| <b>Document Title:</b>  | Updated - Staff Paper - Review of Turlock Irrigation District's 2018–2030 Integrated Resource Plan |

**Review of Turlock Irrigation  
District's 2018-2030  
Integrated Resource Plan**

August 2019 | CEC-200-2019-013

**Figure 2: Turlock and California Energy Commission Energy Forecasts 2019-2030 (GWh)**

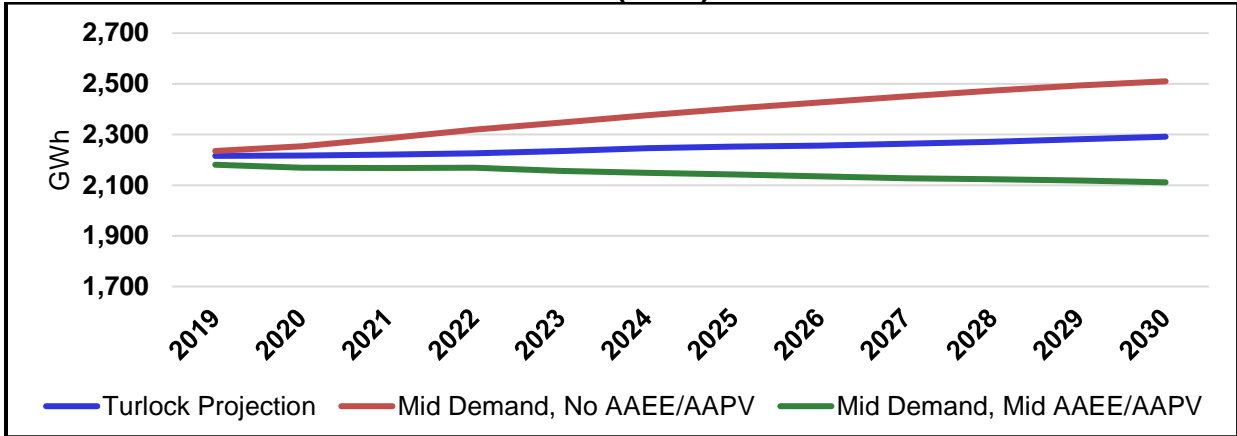
After incorporating assumptions regarding customer PV, energy efficiency, and transportation electrification, Turlock projects energy demand to grow at 0.4 percent per year through 2030 to nearly 2,300 GWh. This growth rate is lower than has been observed historically. The utility's projection lies between the CEC's Mid Demand, No additional achievable energy efficiency (AAEE)/ additional achievable photovoltaic (AAPV) case and Mid Demand, Mid AAEE/AAPV case.<sup>11</sup> Load growth for 2018 and 2019 is expected to be higher than growth for the remainder of the planning horizon due to the addition of several new industrial customers.

Distributed solar PV in Turlock’s service territory grew by 47 percent annually between 2012 and 2017, from 5 to 35 MW. The utility projects continued solar capacity growth of 7.5 percent per year from 35 MW in 2017 to 87 MW in 2030. Energy produced by these resources is expected to increase from 67 GWh in 2019 to 145 GWh in 2030, which equals about 6.6 percent of forecasted energy load in 2030.

**Figure 3: Turlock and California Energy Commission Peak Demand Forecasts, 2019-2030 (MW)**

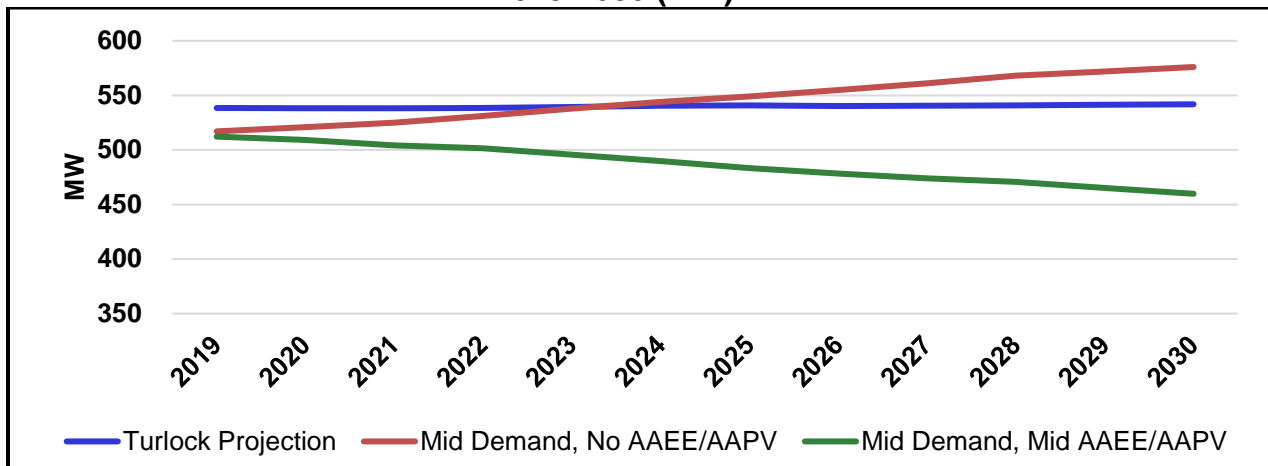
**Figure 3** presents the peak demand forecast for Turlock for 2019 to 2030 and compares it to CEC forecasts.<sup>12</sup>

During the outer years of the planning horizon, the Turlock forecast is lower than the CEC's Mid Demand, No AAEE/AAPV forecast, but higher than the CEC's Mid Demand, Mid AAEE/ AAPV forecast. The CEC embeds committed energy efficiency savings in its forecast, while Turlock's forecast embeds committed energy efficiency and AAEE.<sup>13</sup> The disparity in the treatment of energy efficiency savings could explain some of the differences between the forecasts.

Turlock projects that distributed PV over the planning horizon will reduce its peak demand from 12 MW in 2017 to 41 MW in 2030.

**Figure 4: RPS Energy and RECs, 2019-2030 (MWh)**

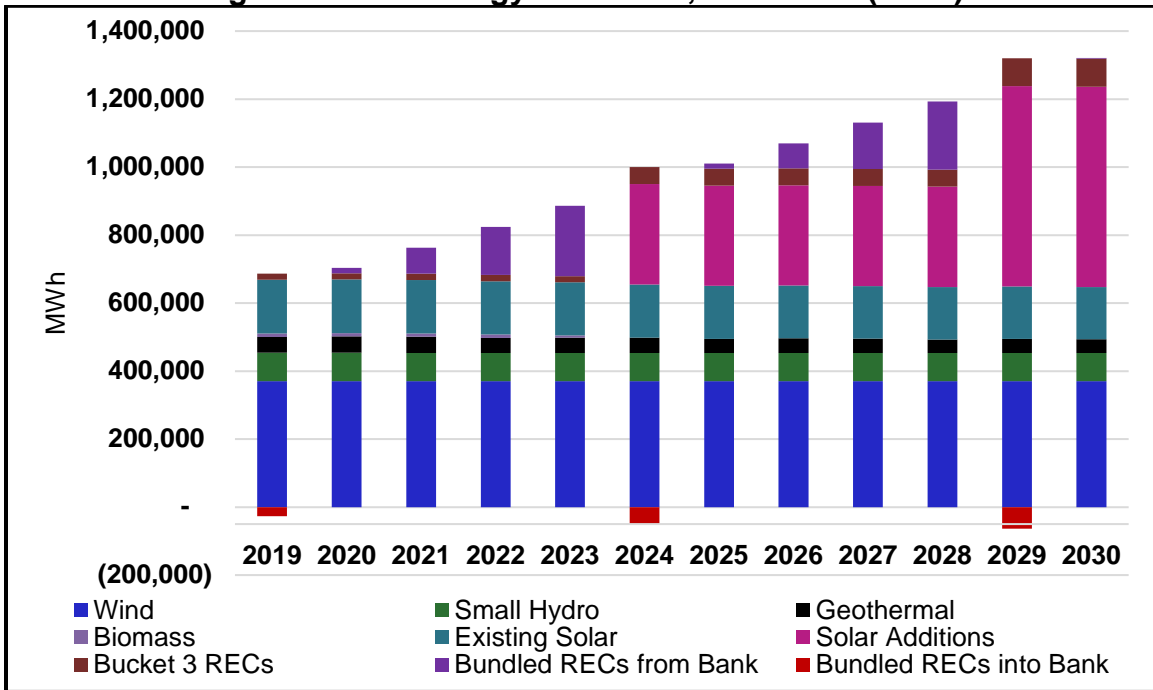
Turlock plans to meet a 60 percent RPS by 2030, with at least 65 percent coming from owned renewable resources or renewable resources under contracts of 10 years or more. **Figure 4** illustrates how Turlock anticipates meeting the 60 percent RPS for 2030 and associated interim requirements.

Current projections show Turlock producing more RECs than required in 2018 and 2019. Turlock added to its bank of RECs in 2018 and anticipates adding 27,000 MWh of RECs in 2019, shown as a negative entry in **Figure 4**. Turlock anticipates that the use of RECs will allow it to meet RPS requirements through 2023 without procuring renewable energy beyond existing utility-owned generation and resources currently under contract.

**Figure 5: Turlock Renewable Energy Procurement, 2019 and 2030**

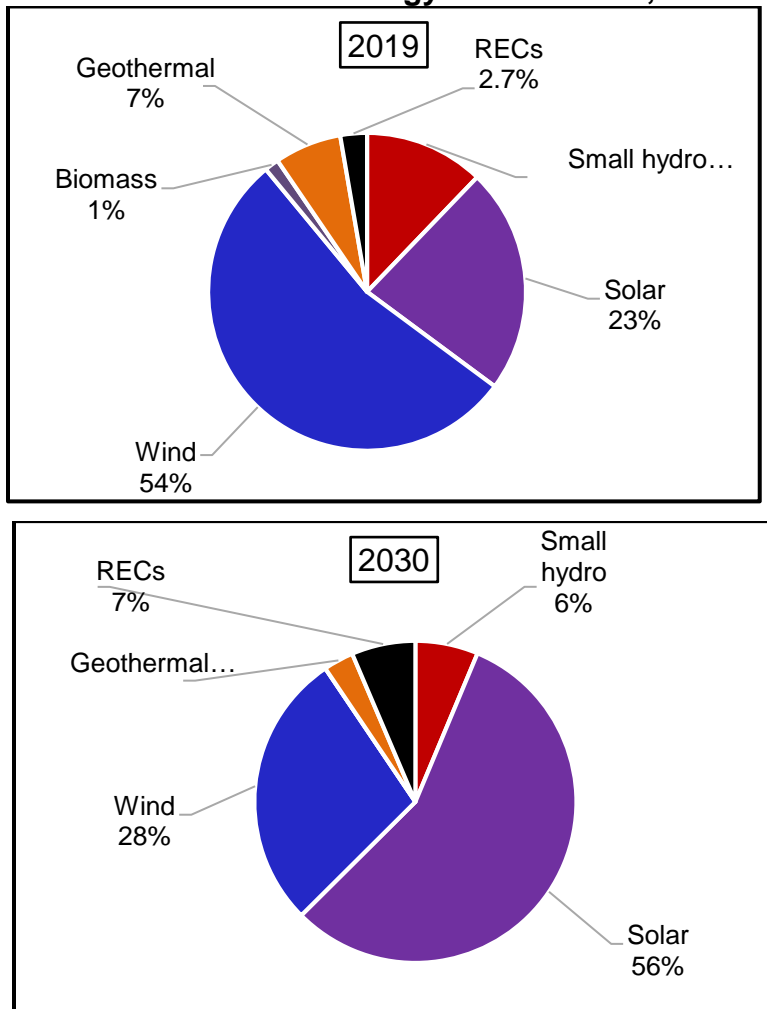
**Figure 5** illustrates how the composition of Turlock’s renewable energy changes from 2019 to 2030. Turlock’s renewable portfolio shifts from 55 percent wind and 24 percent solar in 2019 to 30 percent wind and 60 percent solar in 2030. Small hydro decreases from 13 percent in 2019 to 7 percent in 2030, while geothermal decreases from 7 percent in 2019 to 3 percent in 2030. By 2030, biomass is eliminated from Turlock’s renewable portfolio.

**Figure 6: Turlock Portfolio Comparison for 2019 and 2030 (MWh)**

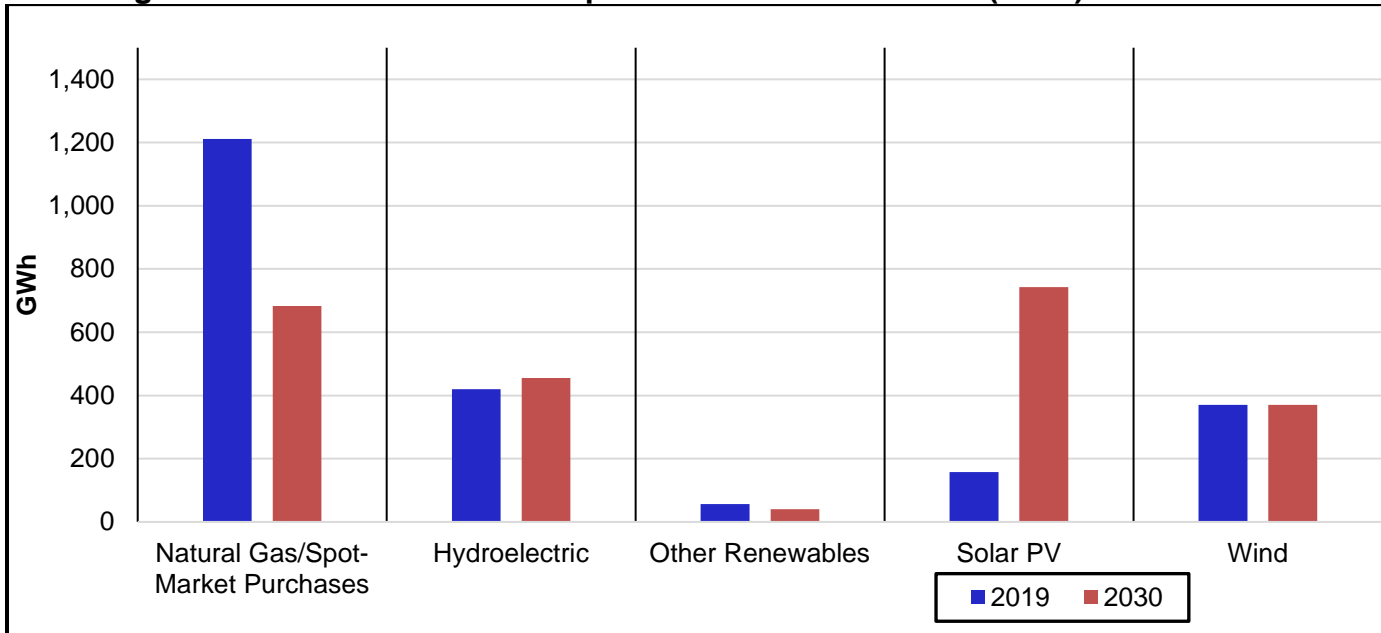
**Figure 6** presents a comparison of the energy mix by fuel type in Turlock’s portfolio in 2019 and 2030.

**Figure 6** shows Turlock’s portfolio transitions from natural gas to solar to meet the GHG emissions reduction target and RPS in 2030.<sup>36</sup> The renewable portfolio is diversified by fuel type (including solar, wind, and geothermal resources), and ownership or contract length, since the utility owns the Tuolumne Wind Project and small hydro plants and can choose any contract length for future solar additions. The natural gas component of the portfolio includes only existing utility-owned generation, leaving the utility flexibility in procuring additional resources to meet future energy and capacity needs.
